Design Compliance Report

REF Submission Design Review

Greenway Park Public School Upgrade and New Public Pre School at Wyattville Drive, West Hoxton, NSW

Report Number & Revision:	**MSA2623_BCA_GRE_1**
Prepared For:	**NSW Department of Education**
Date of Issue:	**19 February 2025**

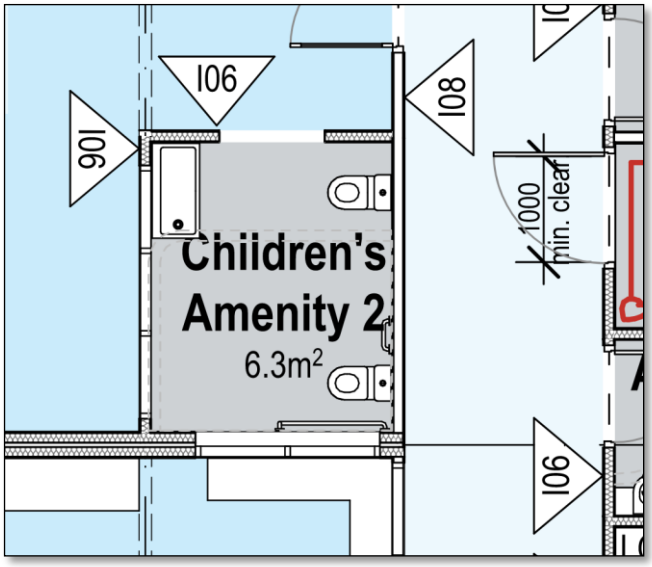
#	DTS Clause	Recommendation	Status
•	*F4D4*	**Preschool Building** The children's sanitary facility (Children's Amenity 2) is required to be accessible from both indoor and outdoor play areas in accordance with Table F4D4g. The current design only allows access from the indoor play area and does not comply.

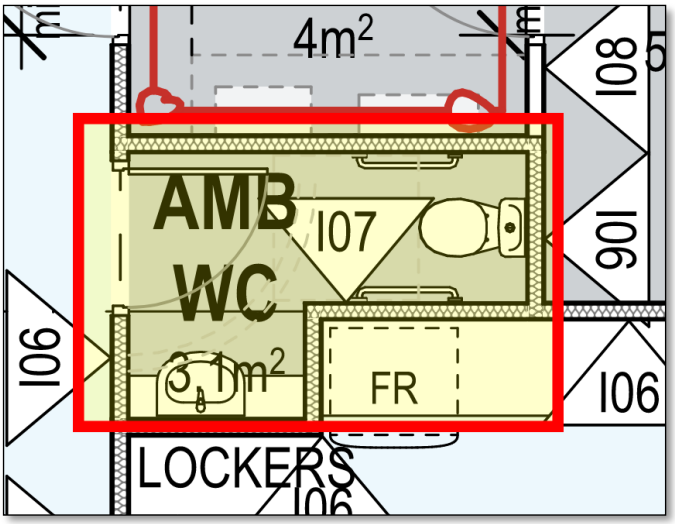
**DOES NOT COMPLY**
•	*F4D5*	**Unisex Ambulant Facilities Not Permitted** Unisex facilities are not permitted under the provisions of this clause. A performance solution may be required to address this issue, or alternatively, two separate ambulant facilities should be provided for male and female use.

**BCA Performance Solution**

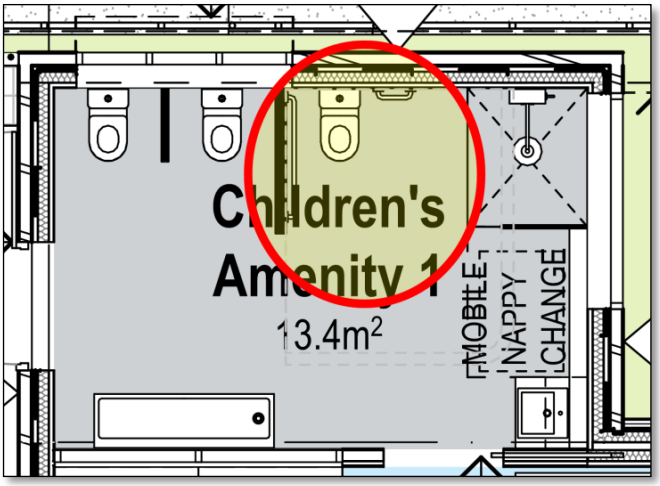
#	DTS Clause	Recommendation	Status
•	*F4D6*	**Children's Amenities Rooms** The design appears to include accessible unisex sanitary facilities within the children's amenities rooms (Rooms 1, 2, and 3). Please note that the requirements for accessible sanitary facilities do not apply to children's sanitary facilities. The design team is requested to provide clarification.

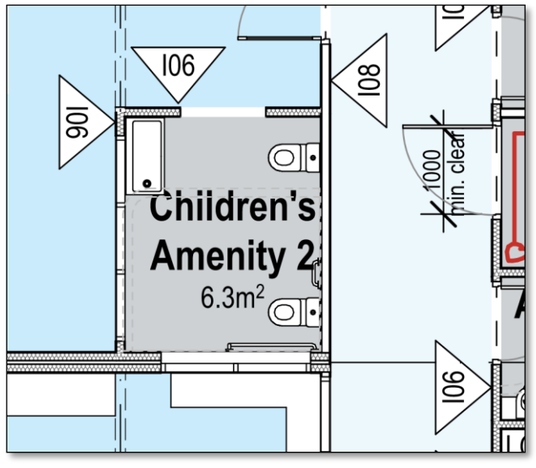
Preschool Building The children's sanitary facility (Children's Amenity 2) is required to be accessible from both indoor and outdoor play areas in accordance with Table F4D4g. The current design only allows access from the indoor play area and does not comply.

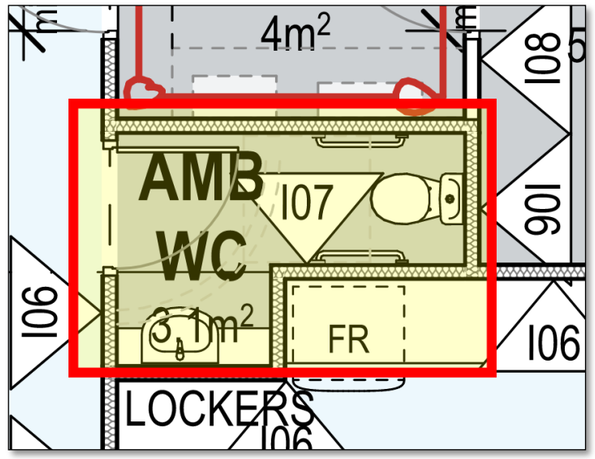
BCA 2019 Cl.	BCA 2022 Cl.	BCA Requirement	Compliance Comment	Status
F2.4	F4D5	**Accessible sanitary facilities** In a building required to be accessible— • accessible unisex sanitary compartments must be provided in accessible parts of the building in accordance with F4D6; and • accessible unisex showers must be provided in accordance with F4D7; and • at each bank of toilets where there is one or more toilets in addition to an accessible unisex sanitary compartment at that bank of toilets, not less than one sanitary compartment suitable for a person with an ambulant disability for use by males and one sanitary compartment suitable for a person with an ambulant disability for use by females, must be provided; and • an accessible unisex sanitary compartment must contain a closet pan, washbasin, shelf or bench top and adequate means of disposal of sanitary products; and • the circulation spaces, fixtures and fittings of all accessible sanitary facilities provided in accordance with F4D6 and F4D7 must comply with the requirements of AS 1428.1; and • an accessible unisex sanitary facility must be located so that it can be entered without crossing an area reserved for one sex only; and • where two or more of each type of accessible unisex sanitary facility are provided, the number of left and right handed mirror image facilities must be provided as evenly as possible; and • where male sanitary facilities are provided at a separate location to female sanitary facilities, accessible unisex sanitary facilities are only required at one of those locations; and • an accessible unisex sanitary compartment or an accessible unisex shower need not be provided on a storey or level that is not required by D4D4(f) to be provided with a passenger lift or ramp complying with AS 1428.1.	**Unisex Ambulant Facilities Not Permitted** Unisex facilities are not permitted under the provisions of this clause.

**BCA Performance Solution**

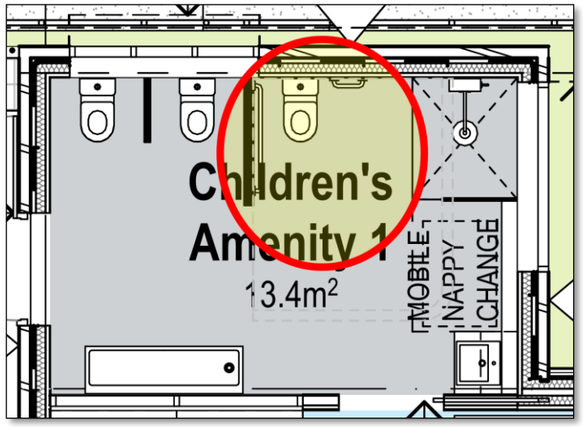
Table F2.4a	F4D6	**Accessible unisex sanitary compartments** Where required by F4D5(a), the minimum number of accessible unisex sanitary compartments for each class of building is as follows: • For a Class 1b building— ○ not less than 1; and ○ where private accessible unisex sanitary compartments are provided for every accessible bedroom, common accessible unisex sanitary compartments need not be provided. • For a Class 2 building, where sanitary compartments are provided in common areas, not less than 1. • For Class 3 and Class 9c buildings— ○ in every accessible sole-occupancy unit provided with sanitary compartments within the accessible sole-(i) occupancy unit, not less than 1; and ○ at each bank of sanitary compartments containing male and female sanitary compartments provided in common areas, not less than 1. • For Class 5, 6, 7, 8 or 9 buildings, where F4D4 requires closet pans— ○ 1 on every storey containing sanitary compartments; and ○ where a storey has more than 1 bank of sanitary compartments containing male and female sanitary compartments, at not less than 50% of those banks. • For a Class 10a building, at each bank of sanitary compartments containing male and female sanitary compartments, not less than 1.	The design appears to include accessible unisex sanitary facilities within the children's amenities rooms (Rooms 1, 2, and 3). Please note that accessibility requirements do not apply to children's sanitary facilities. The design team is requested to provide clarification.
